**Appendix G**  
**On-Site Inspection Notes**

**Fram Whitewater Unit Master Development Plan**

**On-Site Inspection Notes**

**December 11 and 12, 2012**

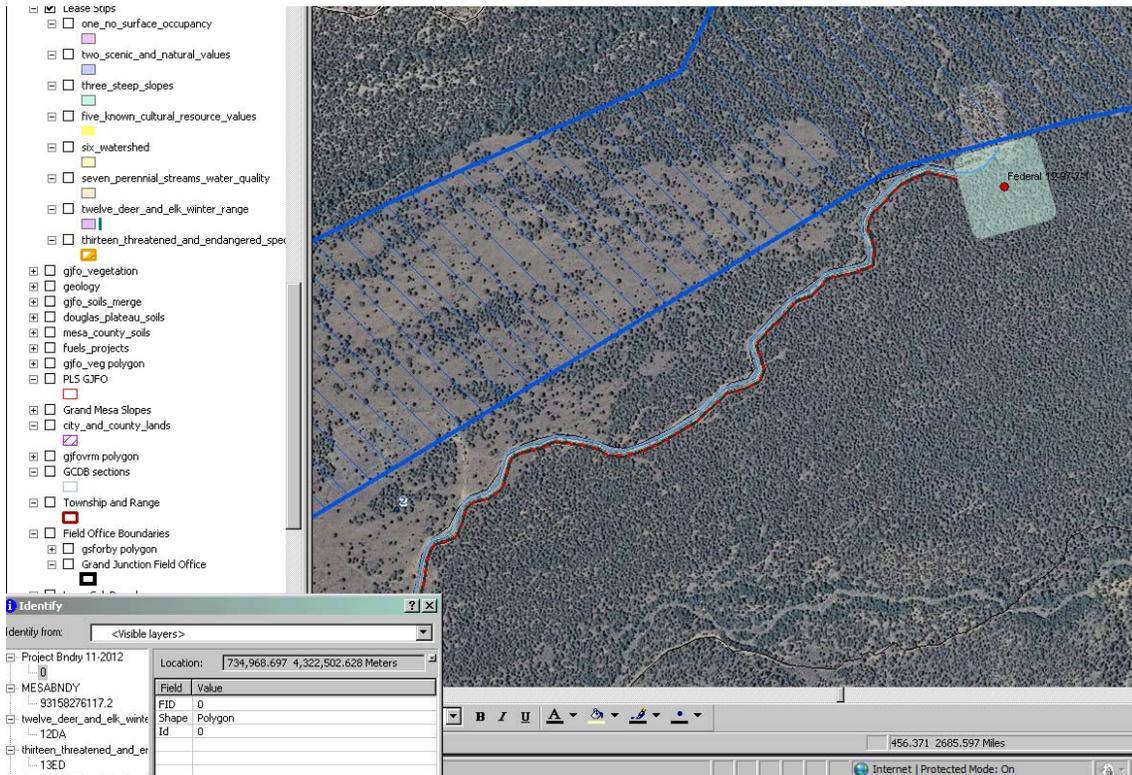
- Rock storage possibilities should be considered and decided at the pre-construction inspection. Rocks could be dozed to access end of pad and then stored or bermed. Topsoil will likely include rocks. The previously disturbed pad might be a place to store rocks. If native materials are needed for naturalizing or mitigating visual impacts, or for armor or road surfacing, these rocks could be used.
- A BLM firewood cutting permit should be purchased before vegetation removal begins.

- The proposed well pad (inspected on December 11, 2012) was moved south (approximately 200 feet) and rotated so that natural (storm water) drainage from the location would flow toward Whitewater Creek rather than Brandon Ditch.
- Aboveground facilities should be painted BLM color “Yuma.”

Proposed pad 13-97-8-2, showing Winter Range (purple), T&E (orange hatch) lease stip areas. Note two possible access roads off Kannah Creek Road. Both are on private, different owners.

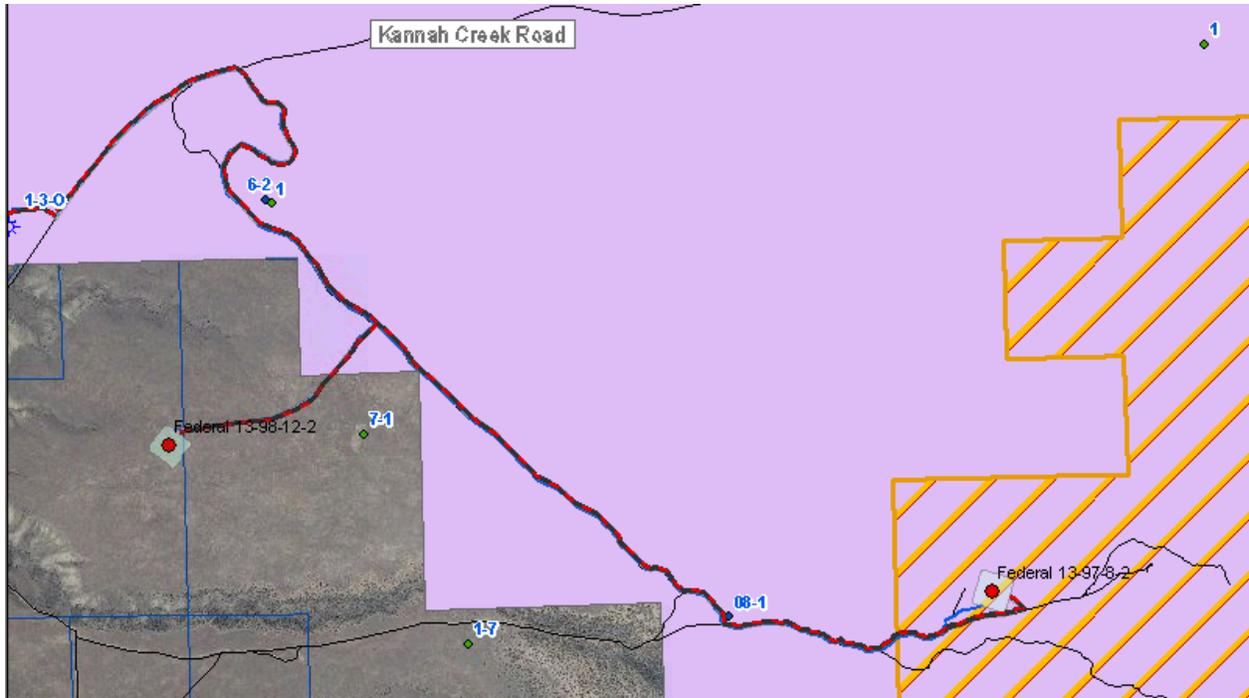
- The proposed access across private lands shall be determined and depicted in applications for road and pipelines. Certification that a Surface Use Agreement is in place, signed by the operator and the landowner, would be provided to the BLM.
- Steep rough roads and slumping soils shall be site-specifically considered for access, including road design/improvements, possible engineering and storm water controls.
- If the well pad is located on the ridge in a way that it is easily visible from the road, low-profile equipment no taller than 15 feet shall be required.
- Aboveground facilities shall be painted BLM color “Yuma.”
- Surveys and/or protections for Threatened and Endangered Species could be required.

Map showing pads 1-2-15-1 (Horse Mtn), 1-2-16-1, 1-2-22-1 relative to one another (note square mile graphic) settled areas and proposed routes. Visual resource protection stip applies.

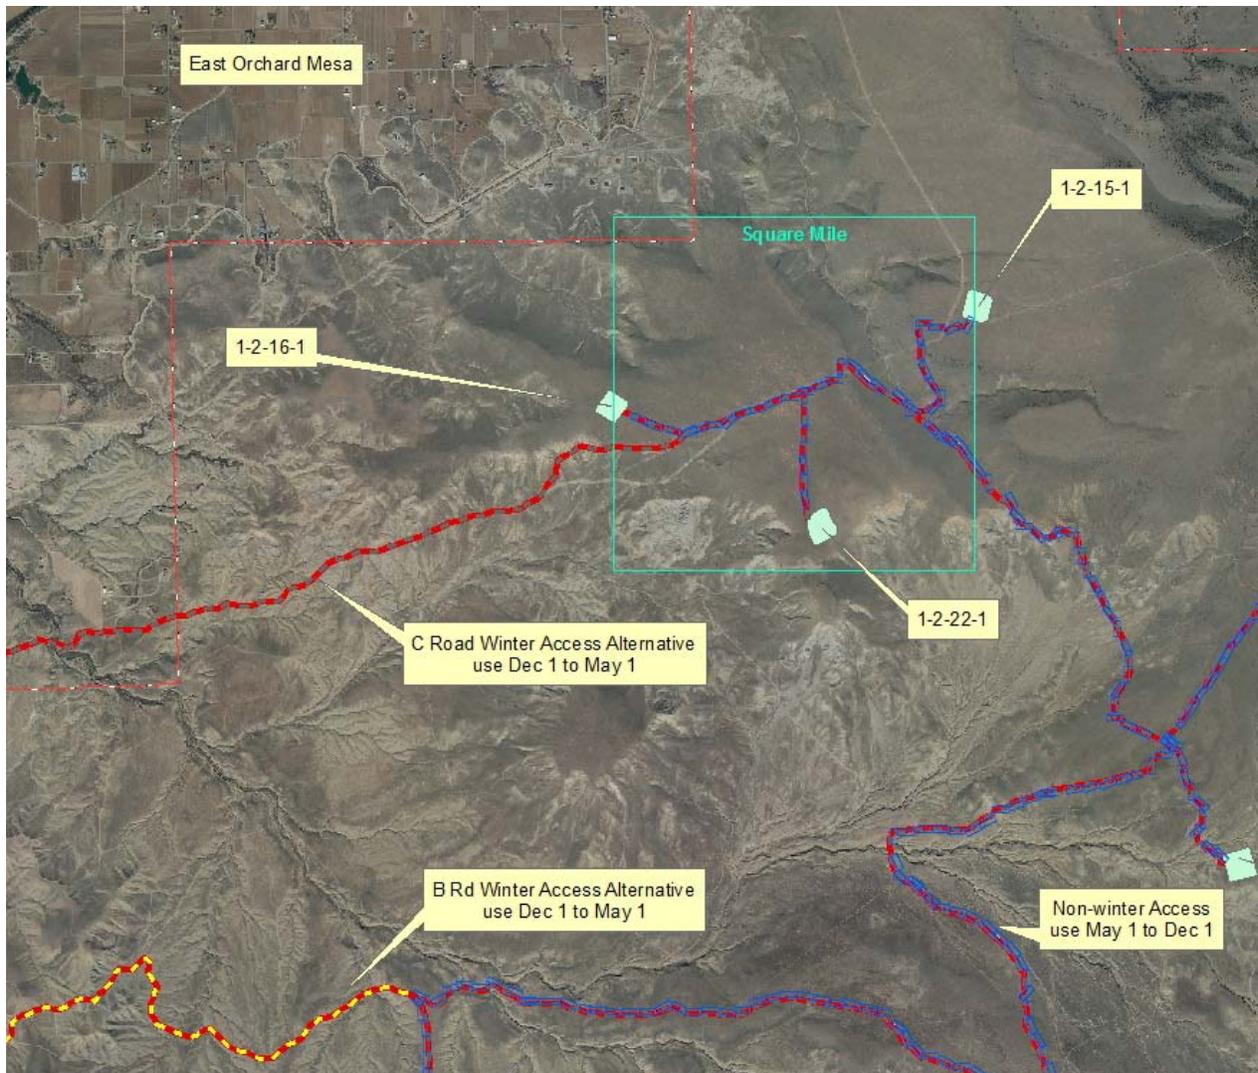
- 
- Colorado hookless cactus plants are located within 100 meters of the proposed pad disturbance limits. Install fence and / or post signs on the southern edges of proposed disturbance.

- If the proposed pad needs to be adjusted, make sure the pad does not get closer to the cactus plants than it is currently designed.
  - On-site construction and reclamation should be monitored to ensure that no disturbance occurs beyond the project disturbance limits.

- Measures to minimize visual impacts should be considered on the fill side of the pad.
  - Noise mitigation (such as mufflers, sound baffling barriers, berms) should be implemented, as needed.
